PIC16C62B Rev. A Silicon Errata Sheet

The PIC16C62B (Rev. A) parts you have received conform functionally to the Device Data Sheet (DS35008A), except for the anomalies described below.

FIGURE 1: $\overline{\text{MCLR}}$ EXTERNAL CIRCUIT

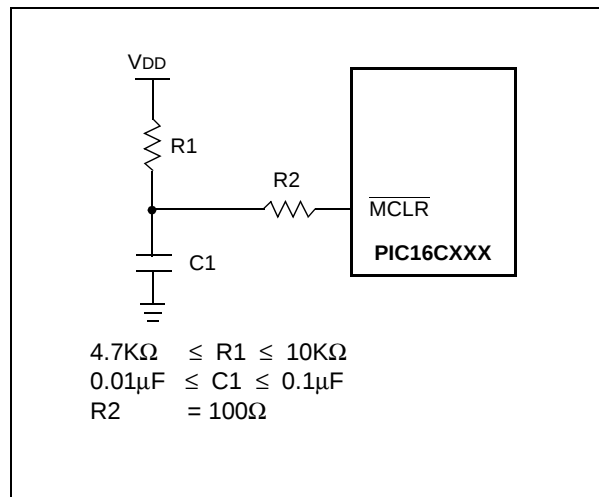
1. Module: RESET

The minimum specification for the $\overline{\text{MCLR}}$ must be met in order to RESET the PIC16CXXX. If a $\overline{\text{MCLR}}$ pulse occurs that is less than the minimum specification (parameter #30), improper device operation can occur.

If the minimum specification cannot be met, then an external circuit must be used to insure that any pulse width less than the specification will be filtered before it reaches the $\overline{\text{MCLR}}$ pin.

Work Around

A possible circuit is shown in Figure 1. Proper design validation needs to be done to ensure desired operation over the applications operating conditions
